SERVICE BULLETIN

KART-0006

FLY BY WIRE (KART REMOTE SYSTEM)

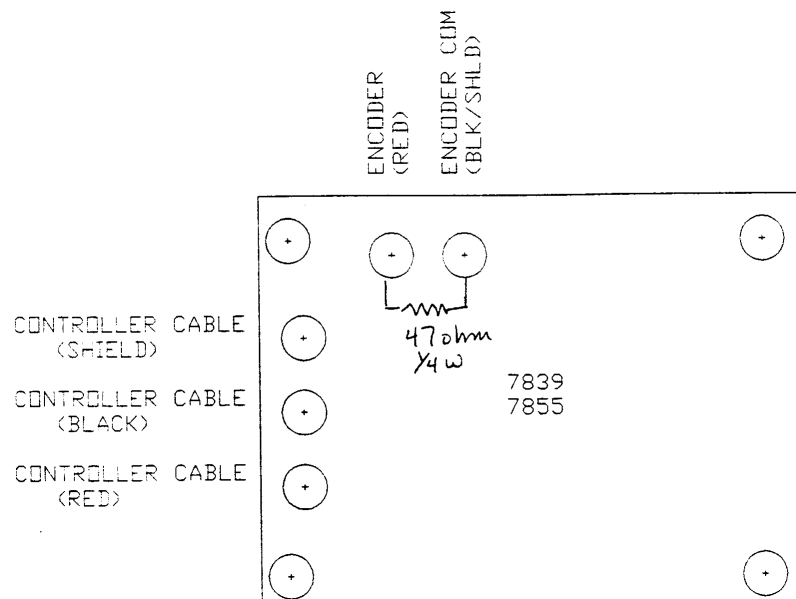
SOME CUSTOMERS ARE REPORTING THAT THE SPEED ADJUSTMENT CAN BE SOMEWHAT ERRATIC. THIS IS CAUSED BY THE ENCODER PUTTING OUT TOO MANY PULSES. IT IS ONLY NOTICEABLE ON A FEW KARTS, BUT CAN BE SOLVED BY PUTTING A 47 ohm 1/4 w RESISTOR ACROSS THE ENCODER. RESISTORS WILL BE INCLUDED WITH THIS
